SERVICE CAMPAIGN BULLETIN

NTB14-030c

**VOLUNTARY SERVICE CAMPAIGN
2011 - 2013 JUKE TIMING CHAIN**

This bulletin has been amended. A caution for cleaning silicone from the front cover bolt holes was added on page 28. Please discard previous versions of this bulletin.

Figure 45a

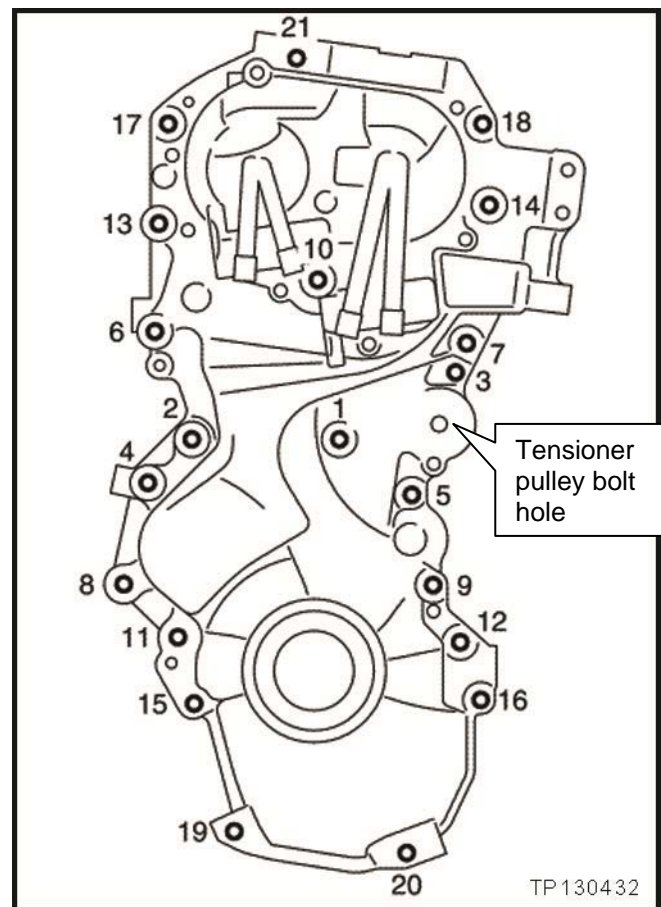
- Clean excess silicone out of bolt holes 1, 3, 5, 7, 10, 15, 19, 20 (see Figure 45a).
- Also clean excess silicone out of the hole for the belt tensioner pulley bolt hole (see Figure 45a).
- Use a small flat blade screwdriver or other suitable tool to clean excess silicone from the bolt holes.
